Plas Power Solar and Energy Storage Project

3.0.4 Outline Construction Traffic Management Plan

Outline Construction Traffic Management Plan

Stage 1 Road Safety Audit Response

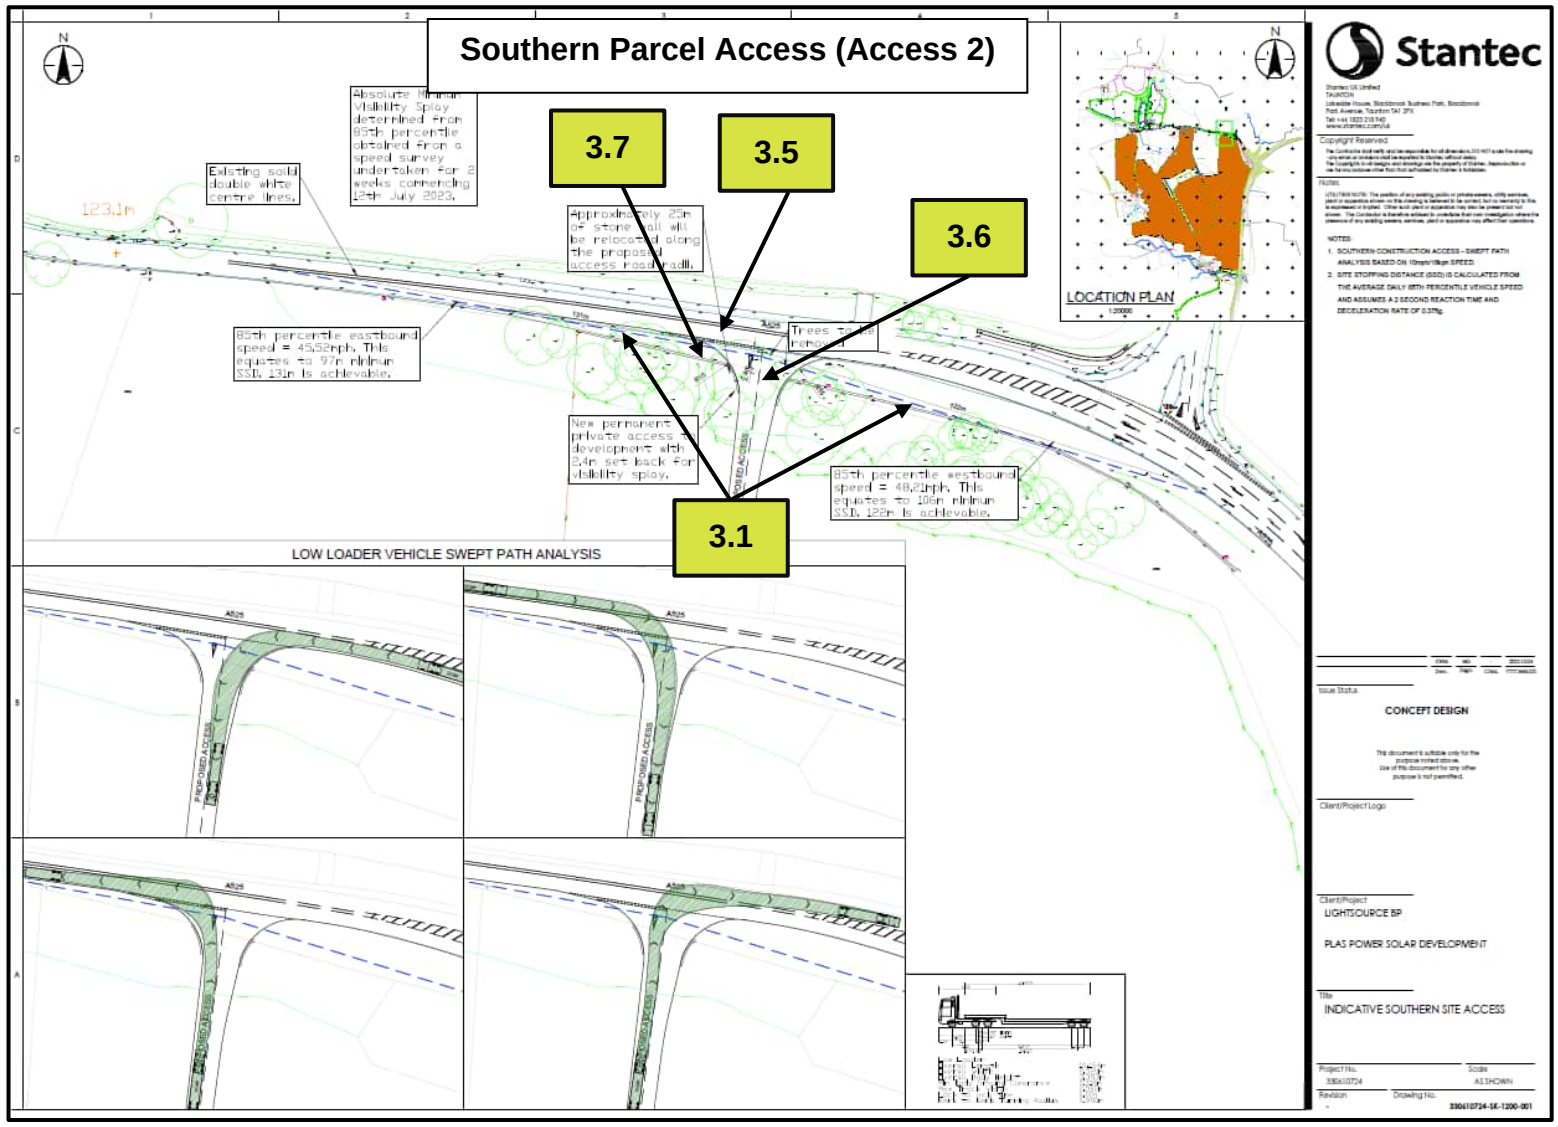
Please refer to the following pages for plans illustrating the locations of the problems identified as part of this audit (location numbers refer to paragraph numbers in the report).

Northern Parcel Access (Access 1)
3.1
3.2
3.3
3.4
Temporary widening during construction to existing access way.
2.0m visibility setback for construction access.
Existing solid double white centre lines.
85th percentile eastbound speed = 47.76mph. This equates to 105m minimum SSD. 112m is achievable.
85th percentile westbound speed = 45.52mph. This equates to 97m minimum SSD. 97m is achievable to solid double white centre lines.
VEHICLE SWEPT PATH ANALYSIS
LOCATION PLAN
Stantec
CONCEPT DESIGN
LIGHTSOURCE BP
PLAS POWER SOLAR DEVELOPMENT
INDICATIVE NORTHERN SITE CONSTRUCTION ACCESS
